April 28, 2017

Subject: NRDC comments regarding ENERGY STAR UPS Draft Version 1.1 and Version 2.0 Specifications

Figure 1: UPS operating load points for hypothetical CEC-compliant desktop computer

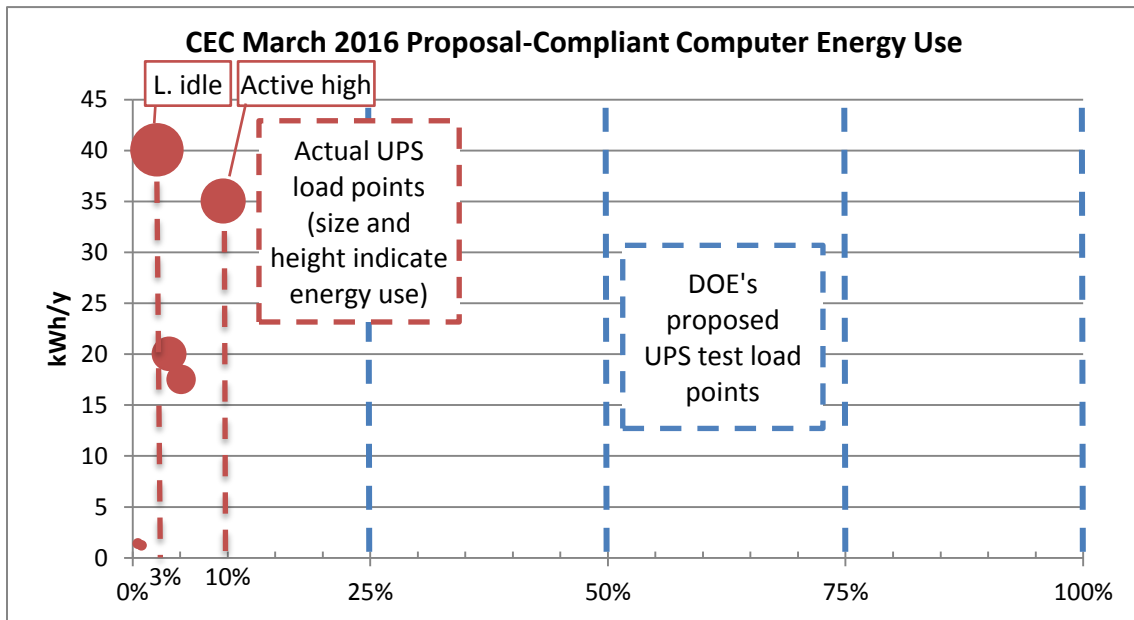
Table 2 shows that **98% of the annual energy use of a modern CEC-compliant desktop computer takes place between 3 and 10% of UPS load**. This shows a large gap between the current test points and the real-world operating range for this type of application.

These results are plotted on Figure 1, and shows that the **proposed test points are not at all representative of the operating conditions of a CEC-compliant desktop computer**.

Therefore, the test points and loading assumptions in EPA’s draft 2.0 specification potentially significantly overestimate UPS efficiency in real-world operation, and incentivize manufacturers to invest in energy efficiency features that may not save energy in the real-world, while leaving low-load energy saving opportunities on the table.

We suggest the following load points and weightings for VFD UPSs:

VFD UPS load point	0%	5%	10%	25%	50%
Weighting	0.1	0.3	0.3	0.15	0.15

Figure 2: ENERGY STAR QPL Efficiency Curves

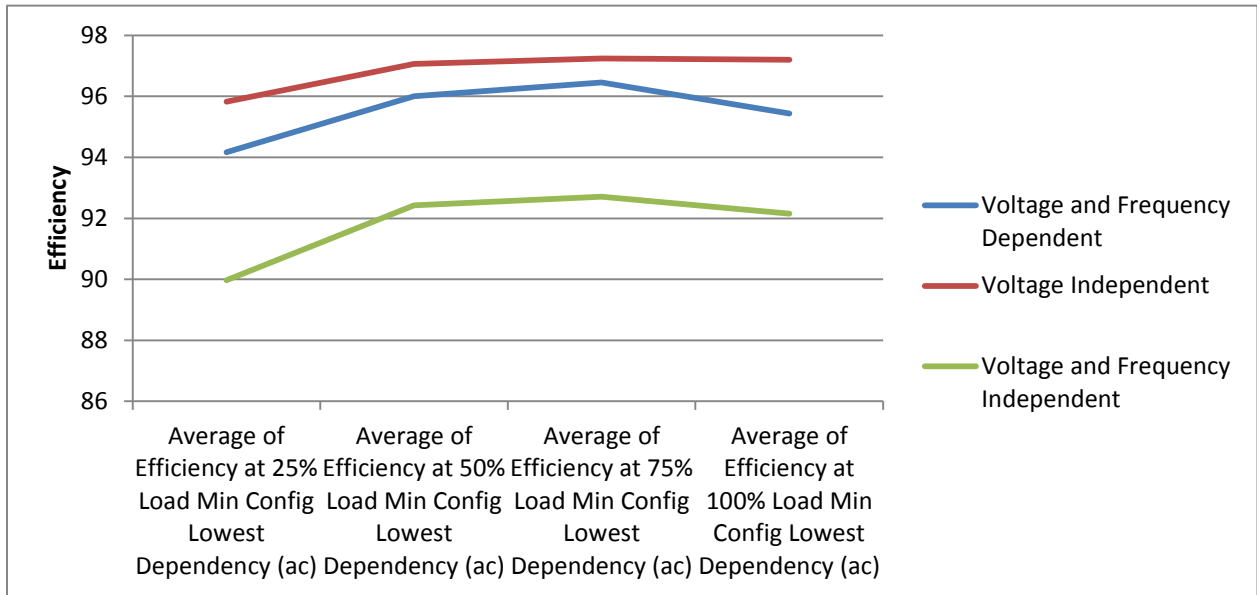
The ENERGY STAR data (despite not being available at loads lower than 25% given the current test procedure) suggests that UPS efficiency drops at lower load as shown in Figure 2.

We recognize that ENERGY STAR does not have the efficiency data at lower load points that is necessary to include those load points in the average efficiency formula. But ENERGY STAR should require the testing and reporting of efficiency at those load points for the following two reasons:

1. To collect data on the efficiency of UPSs at real-world load points and enable the inclusion of these load points in efficiency criteria in a future specification if appropriate;
2. To inform the market on the efficiency of UPSs in real-world operating conditions when used with desktop applications, including standby load (vampire power of the UPS when the desktop is switched off or in sleep mode), and UPS losses when desktops are in idle and low-intensity active mode.
